<b>JRPP No.</b>	<b>2013SYW033</b>
<b>Development Application No.</b>	<b>DA-189/2013</b>
<b>Proposed Development</b>	<b>Construction of a residential flat building containing a total of 113 residential units with basement car parking and site landscaping</b>
<b>Property Description</b>	<b>Lots 1-5 DP 35236, No.34-40 Hume Highway and 1 Browne Parade (Additional frontage to Browne Parade and George Street) WARWICK FARM</b>
<b>Applicant</b>	<b>New Mangrove Pty Ltd</b>
<b>Land Owner</b>	<b>New Mangrove Pty Ltd</b>
<b>Cost of Work</b>	<b>\$24.9 Million</b>
<b>Recommendation</b>	<b>Approval, subject to conditions</b>

## 1. EXECUTIVE SUMMARY

1 SOUTH ELEVATION  
Scale: 1:200

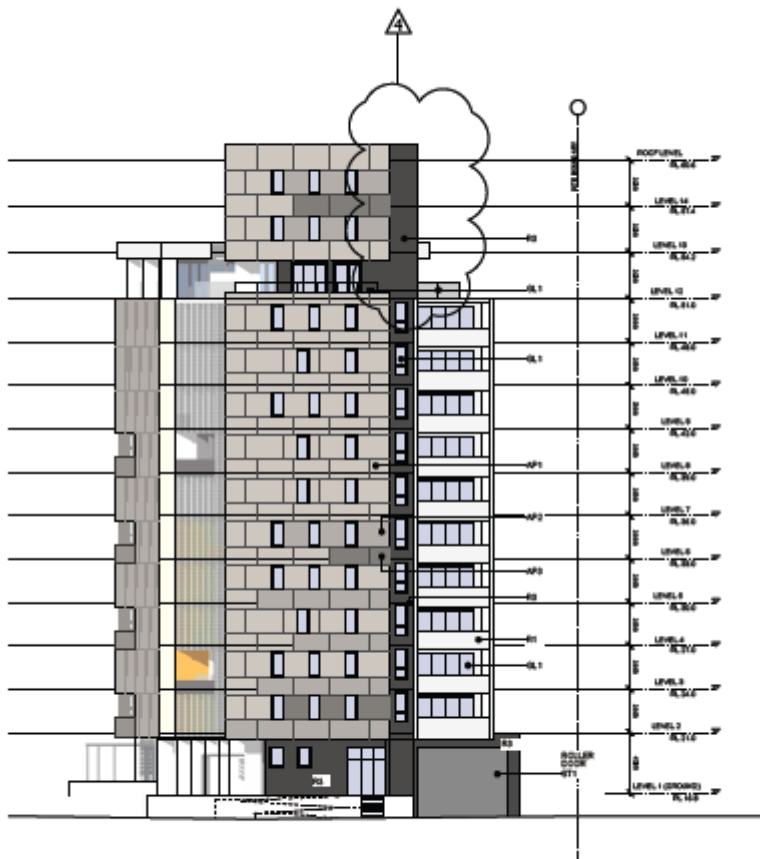
The southern elevation should be amended by varying the vertical alignments of windows to bedrooms and living rooms, and by applying a diversity of panel wall finishes to the eastern and western modules of this elevation in order to complement composition which is currently proposed for the north-eastern and western facades.

*Reasons: Moderate horizontal scale of the visually-prominent southern elevation which is 65m wide. Incorporate improved patterning as a technique to articulate this substantial planar facade, as well as enhancing presentation of south-eastern and south-western corners of the proposed building which would provide visually-prominent backdrops to the City Centre.*

Applicants Response – Amended.

The design has been amended in response to this request. It should be noted that this is a side boundary, and the building is not a “building-in-the-round”. The southern façade will be obscured by the potential 9 to 15 storey building that is likely to be built on the adjoining site in the near future. The elevational treatment on the north-eastern and western facades are not appropriate to this façade. This elevation does not warrant having special “alucobond” panels, as suggested in Council’s letter. The southern elevation has been amended by applying a diversity of patterns and colours to the façade. The walls are patterned in neutral tones and bright colours to break down the scale of the façade. An appropriate amount of façade modulation and patterning has been provided for this side boundary façade. The corners are articulated (see 4 above). The façade is divided into 3 bays by the inset, 3m wide, glazed lobby windows. The walls of these insets are highlighted by bright colours to emphasise their presence in the wall.
